Access Compliance Report

Public Rights-of-Way

(Curb Ramps)

Intersection ID: 15481	Main Street: HEMLOCK_ST	Cross Street: KENILWORTH_AV	Location:	E
ADA ID: DB6F829F6BC3	Ramp Type: PerpDiag	Initial Pass/Fail: Fail	Overall Compliance: No	Severity Score: 35

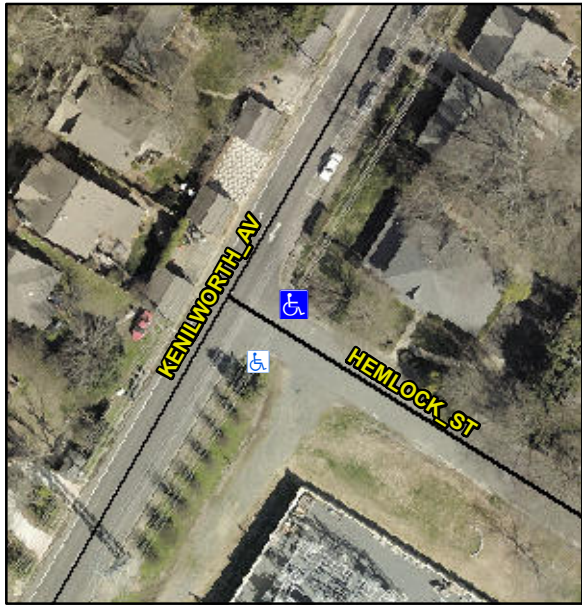
Codes/Mitigation Info/Possible Solution			Field Measurements/Component Compliance										
	Possible Solutions:		Compliance			Description			Data				
	Remove & Replace Curb Ramp With Two New Directional Ramps or Equivalent.		N/A	Ramp Length (in)		48.0		No	Ramp Slope (%)		14.5		
			No	Ramp Width (in)		36.0		No	Ramp XSlope (%)		2.1		
			N/A	Flare Type LT		N/A		N/A	Flare Type RT		N/A		
			N/A	Flare Slope LT (%)		N/A		N/A	Flare Slope RT (%)		N/A		
			N/A	Flare Traversable LT?		N/A		N/A	Flare Traversable RT?		N/A		
			N/A	Landing Length (in)		N/A		N/A	DWS Provided?		N/A		
			N/A	Landing Width (in)		N/A		N/A	DWS Contrast?		N/A		
			N/A	Landing Slope (%)		N/A		N/A	DWS Length (in)		N/A		
			N/A	Landing X Slope (%)		N/A		N/A	DWS Full Width?		N/A		
Surveyor Notes:		N/A			N/A			N/A			N/A		
PROW/ADA:		Not Found, R304.5.1, R304.2.2, R304.5.3			N/A			N/A			N/A		
					N/A			N/A			N/A		
					N/A			N/A			N/A		
					N/A			N/A			N/A
